ADDENDUM NO. 001

RE: Sullivan County Department of Education –Rock Springs
Elementary School Partial HVAC Replacement
T&L Project No. 17119

DATE: July 20, 2023

This Addendum consists of 6 pages and 2 drawing sheets with the revised date of July 20, 2023.

FRESH AIR INTAKE BASE PLAN

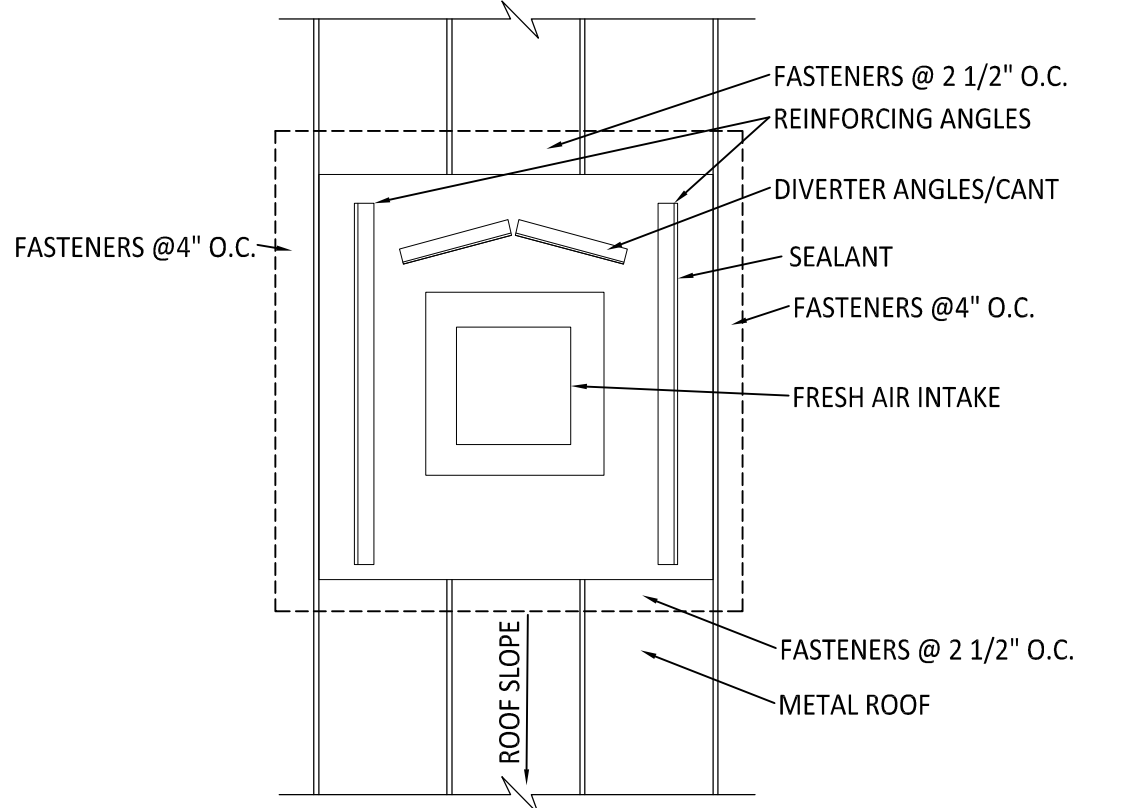
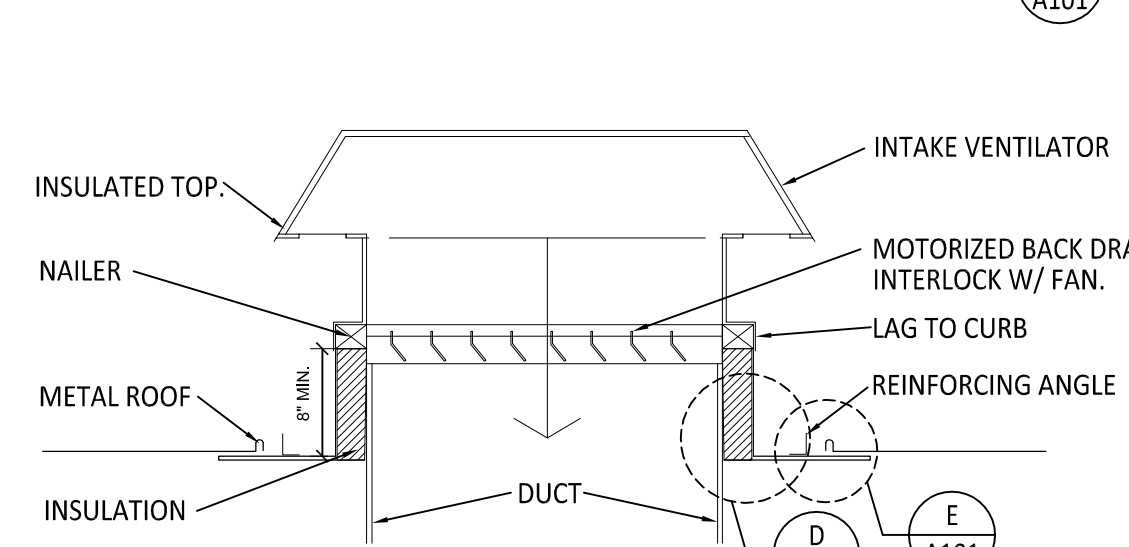
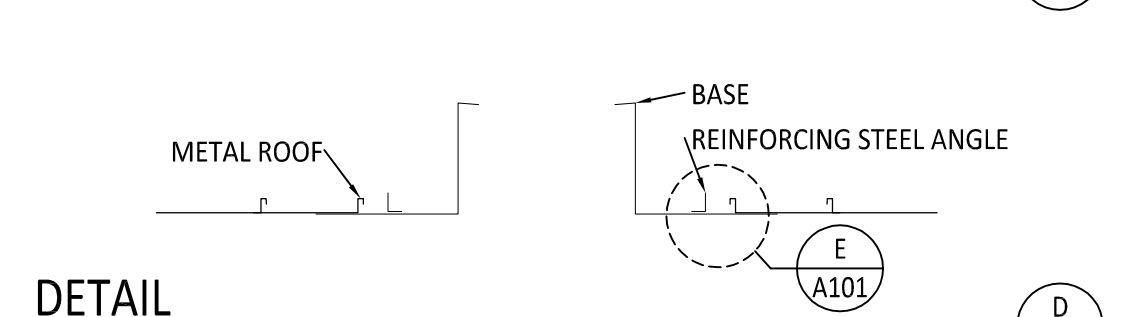
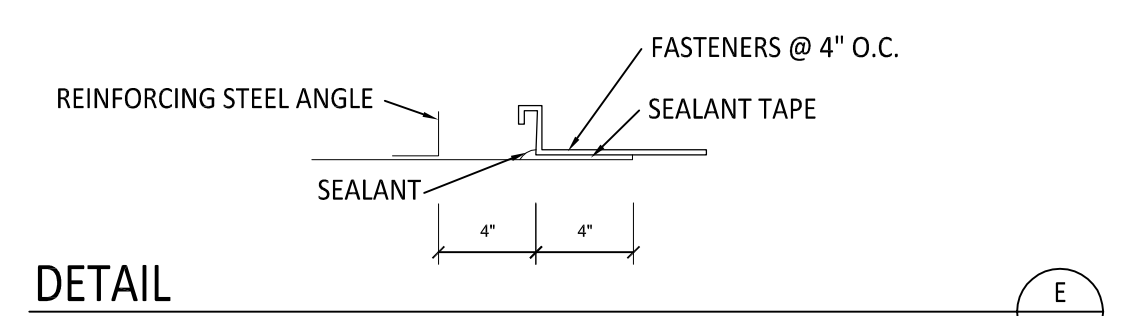
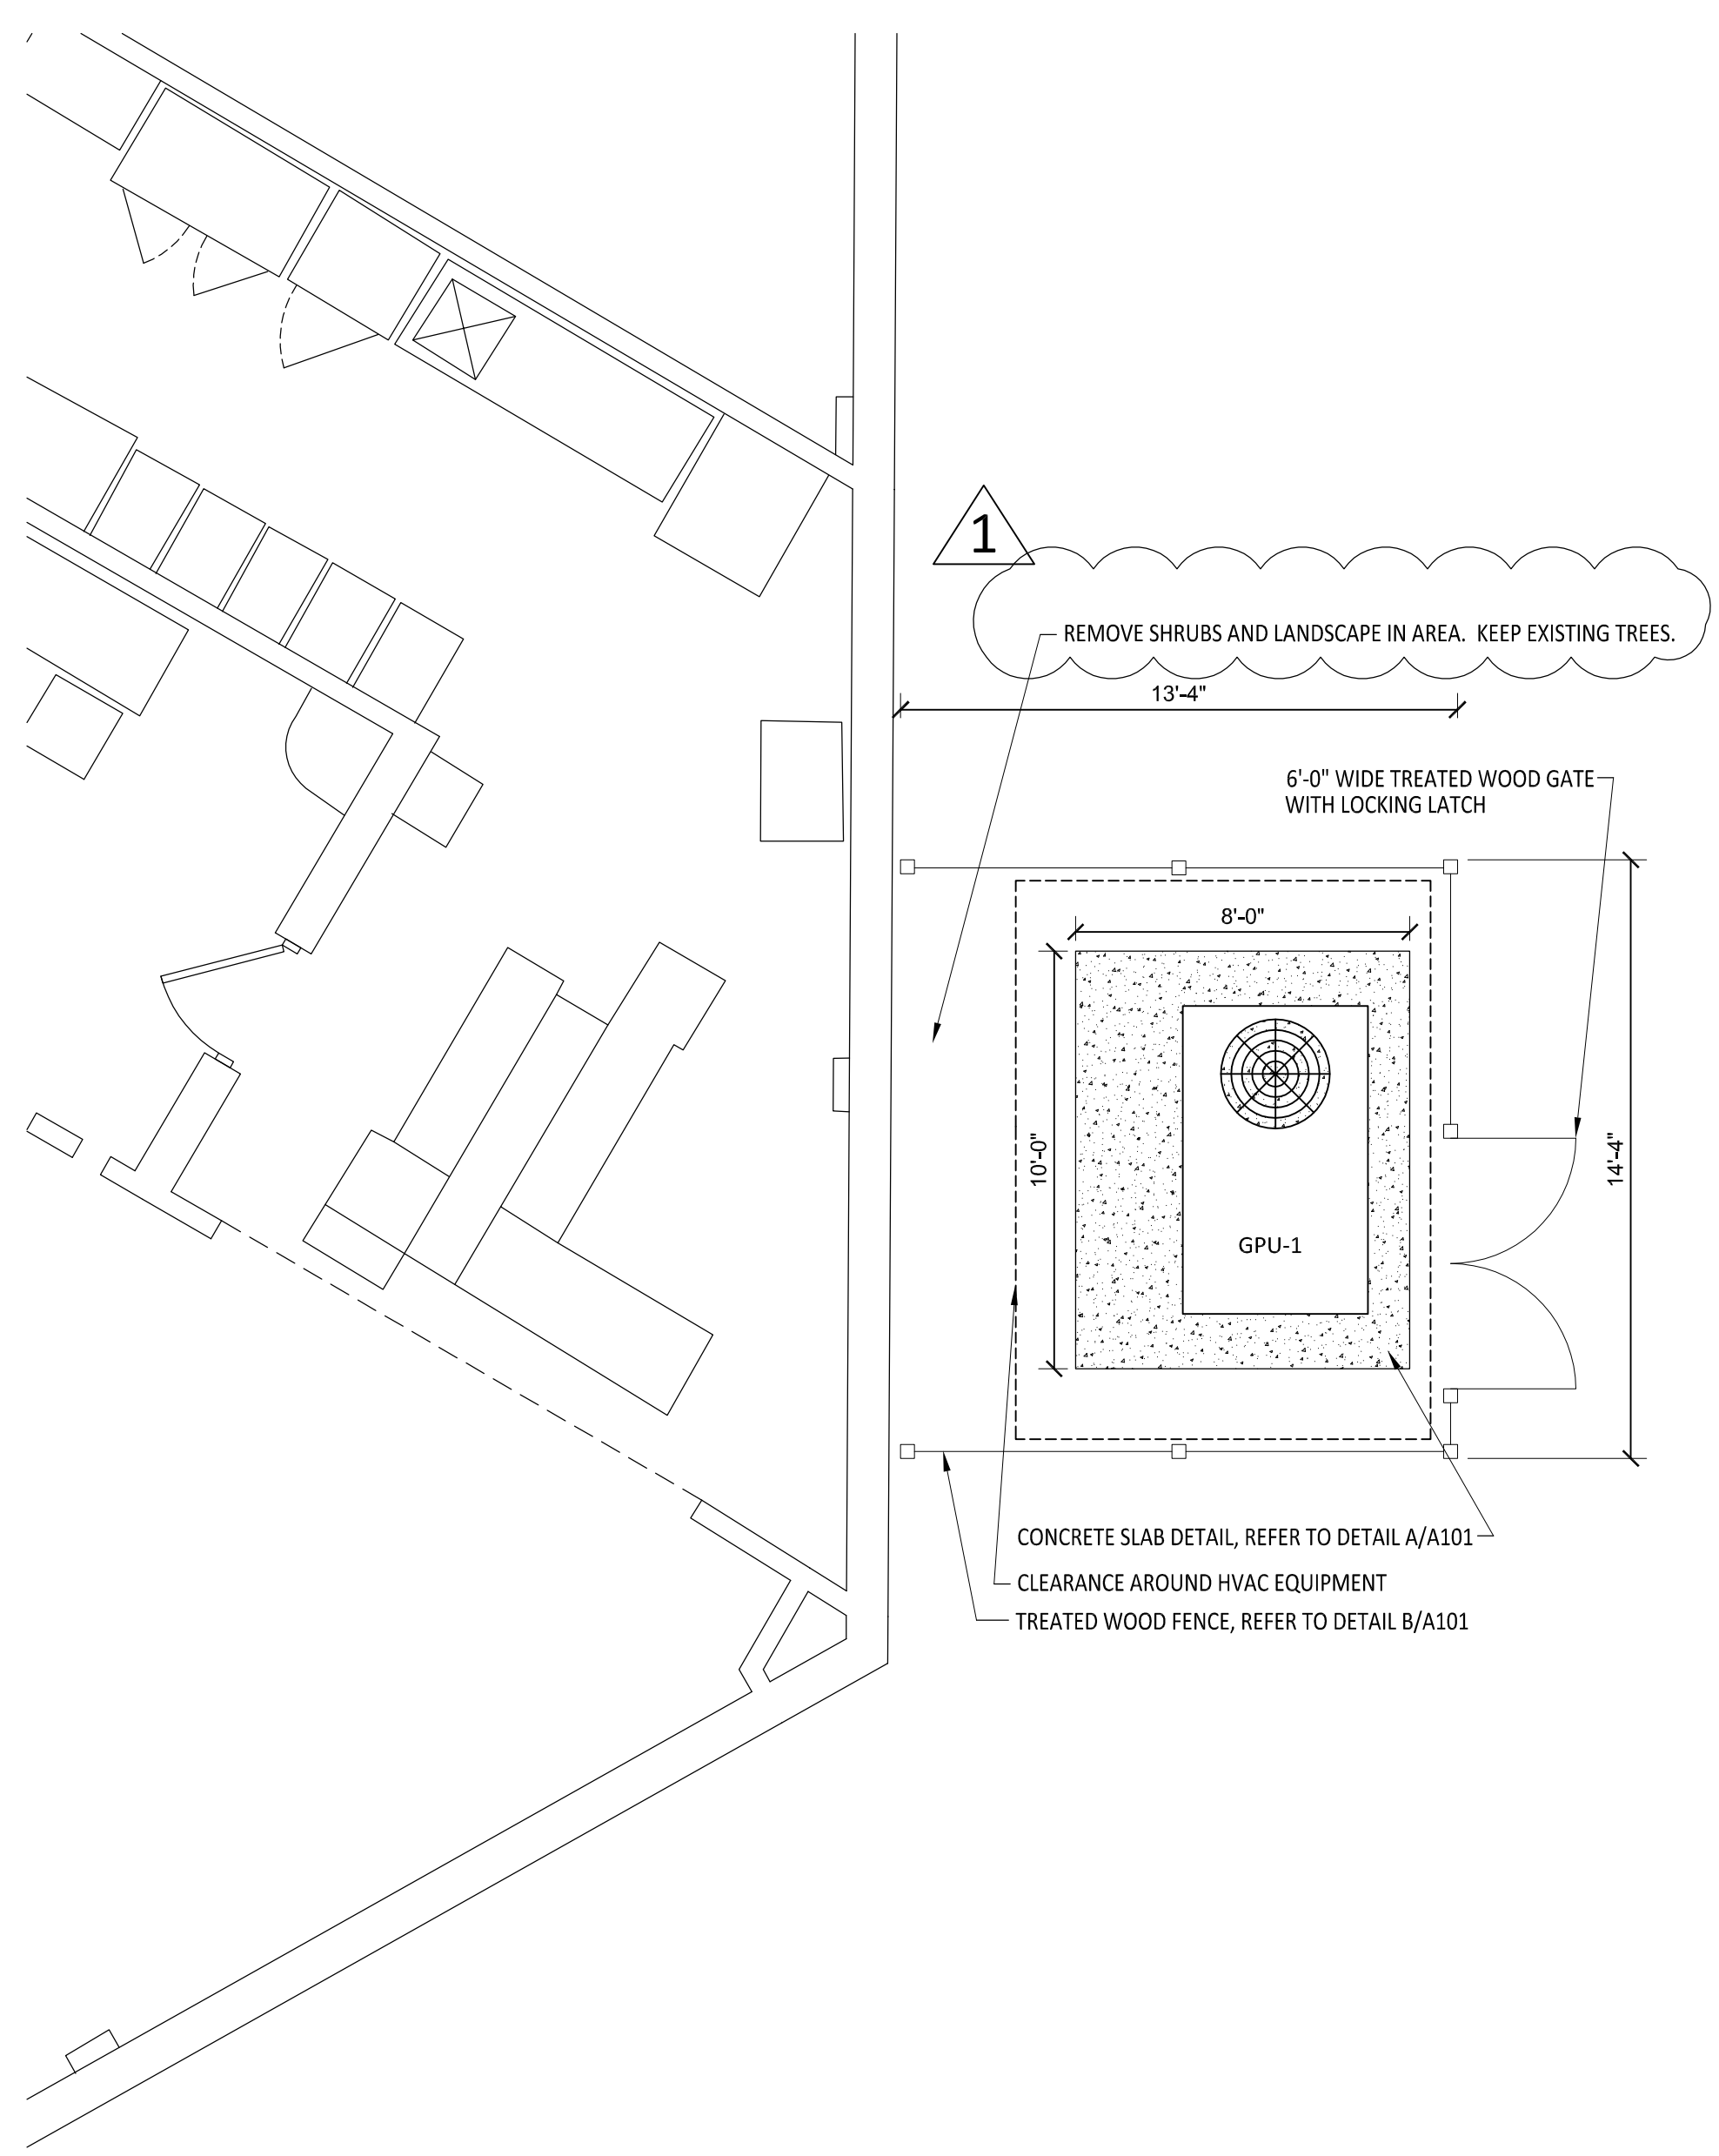
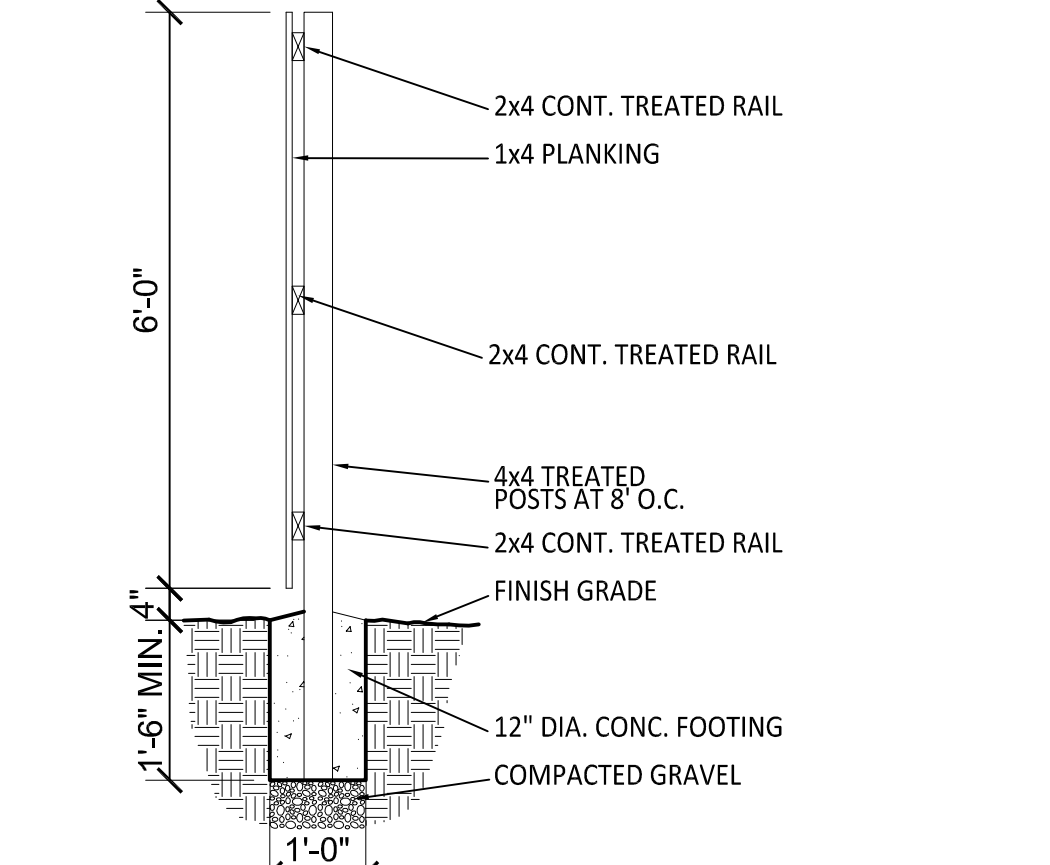
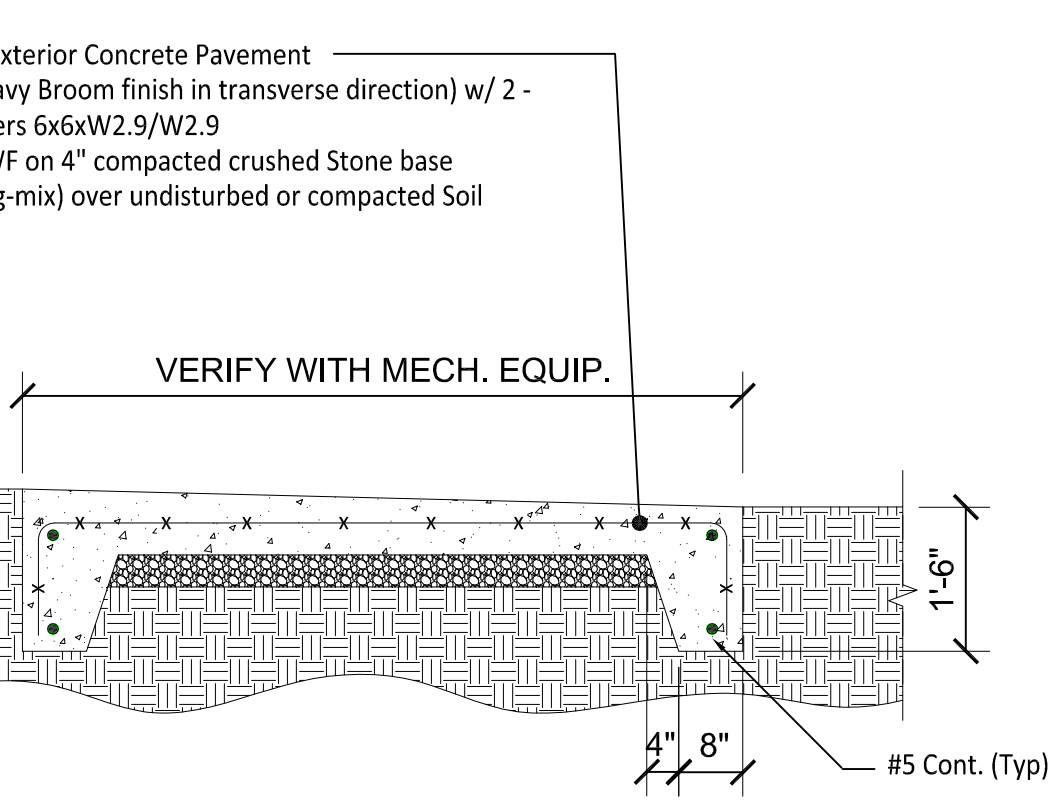
1. Drawing Sheets T001 and A101 are revised with details and notes.
